Sydney Olympic Park Authority, 7 Figtree Drive, Sydney Olympic Park NSW 2127

**DETERMINATION AS EXEMPT DEVELOPMENT UNDER
SYDNEY REGIONAL ENVIRONMENTAL PLAN NO.24 (AMENDMENT 2)-
HOMEBUSH BAY AREA**

The proposed works are to be undertaken at the existing Bicentennial Park Theatrette and include the fitout of the space to operate a bike hire service. The existing theatrette is located adjacent to the existing WatervieW Convention Centre, Bicentennial Park, Sydney Olympic Park.

PROPOSED BIKE SHOP LAYOUT AT BI-PARK.

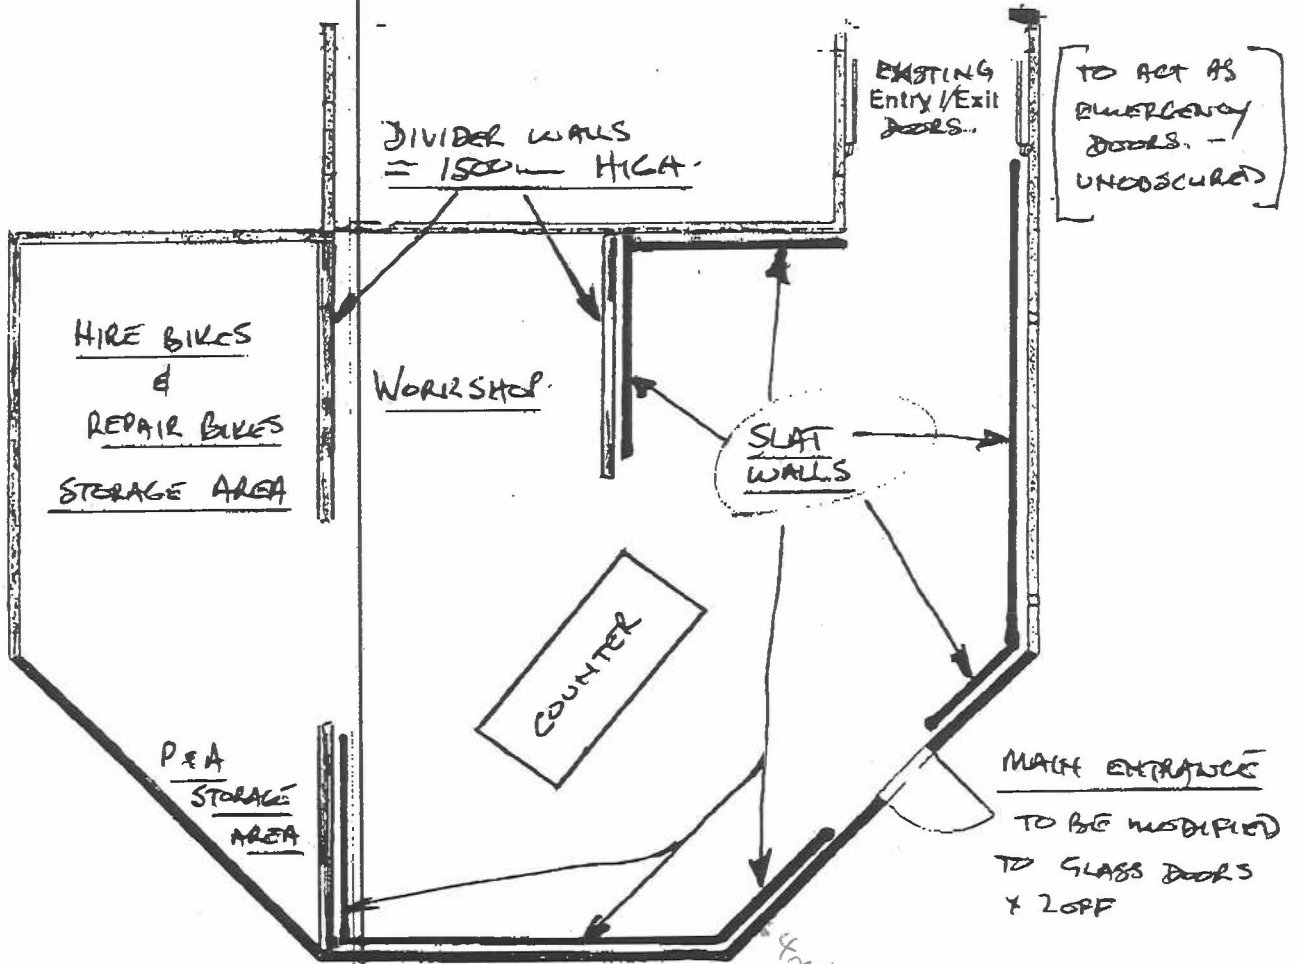
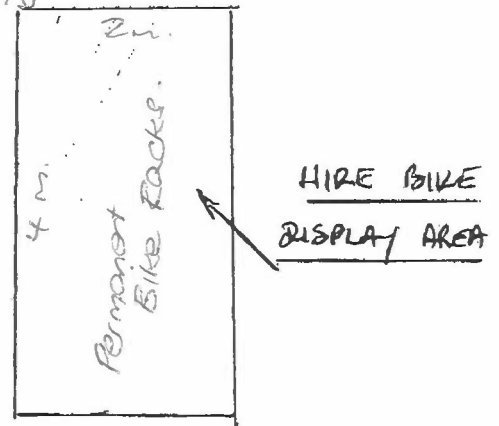
- Details of the existing fire hazard properties of the carpet and wall linings to be submitted;
- The existing Exit sign directing egress to the café is to be removed;
- The entrance door is to be provided with a latch, not a knob;
- The step up into the room at the main entrance is to be ramped either externally, or preferably internally via a concrete cutting;
- A suitable portable fire extinguisher should be installed; and
- No fire safety measures within the existing office and storage area are to be affected by the proposal.
